**Response Narrative**

Project : Entourage in the Sun

P&Z# PZ-22-120000011

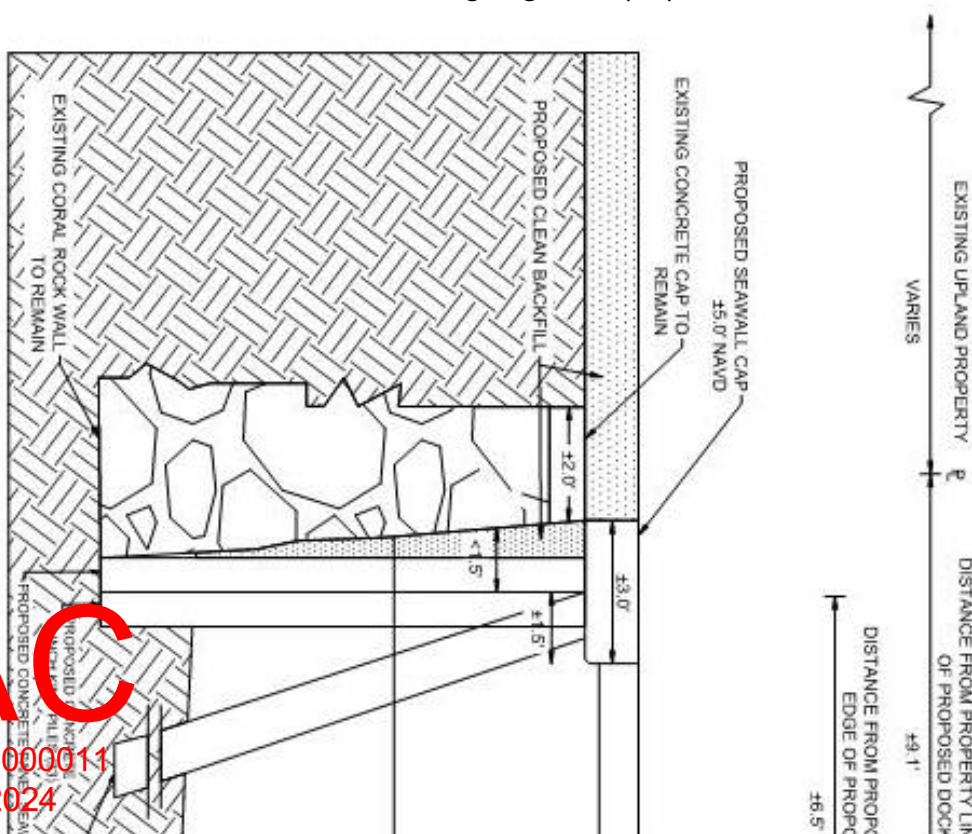
14. Provide clarification on the sea wall that appears on the renderings at the Intracoastal Waterway, and whether it will remain at the existing height or is proposed to be above the existing height.

Response : See attached Actual snapshot from the Chappell Group Dock Construction Shop Drawings for reference. Proposed Height @ 5.0 NAVD + Refer to Civil for additional clarification.
